Formartine Area Committee Report - 25 September 2018

Reference No: APP/2018/1374

**Full Planning Permission for Erection of 3 Dwellinghouses at Hill of Braiklay,
Tarves, Aberdeenshire, AB41 7NS**

EXISTING Location & Site Plan

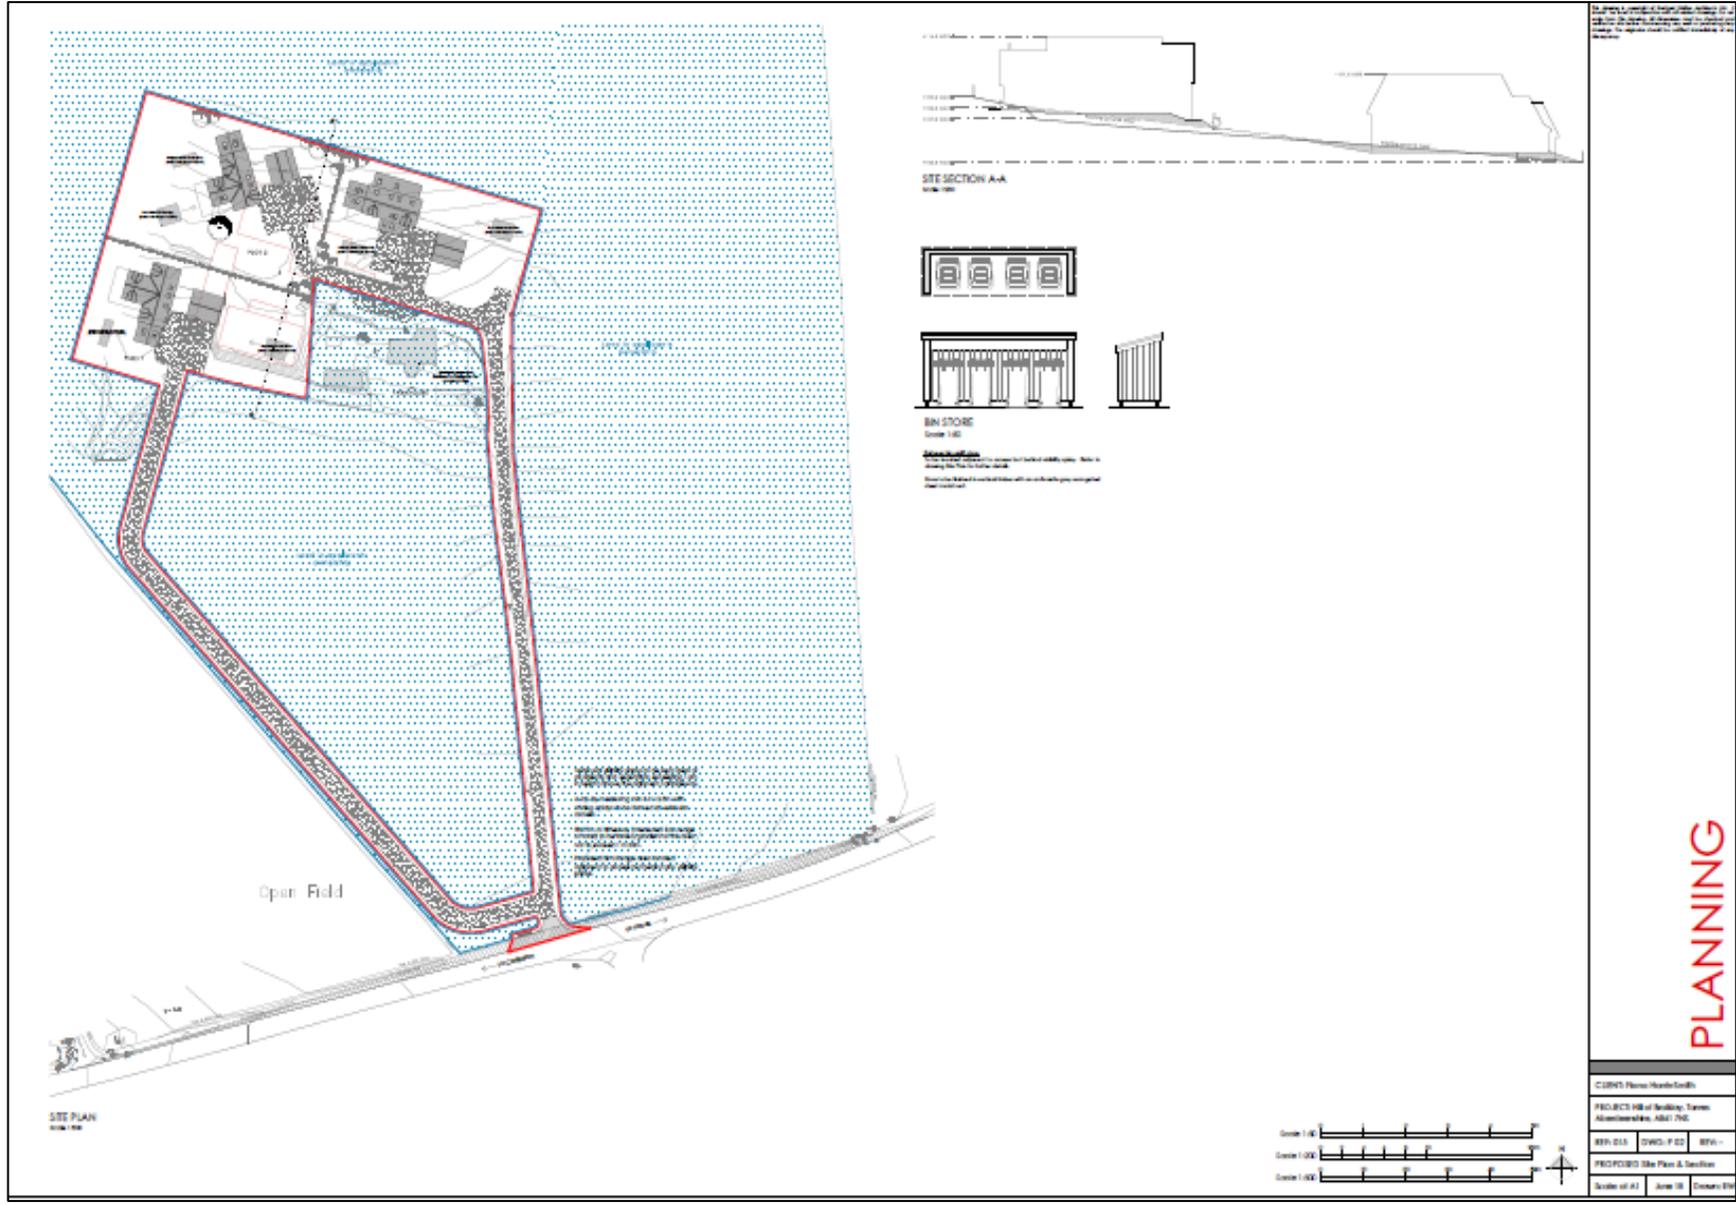
- Existing site plan misleading as it shows a road across the field branching off the Hill of Braiklay access road. Aerial photograph in Design Statement shows the field and site in reality.

The "existing" site plan submitted with the application (DWG P 01) shows a road across the field branching off the Hill of Braiklay access road. This is not correct and is misleading. The aerial photograph included in the Design statement shows the field and site in reality.
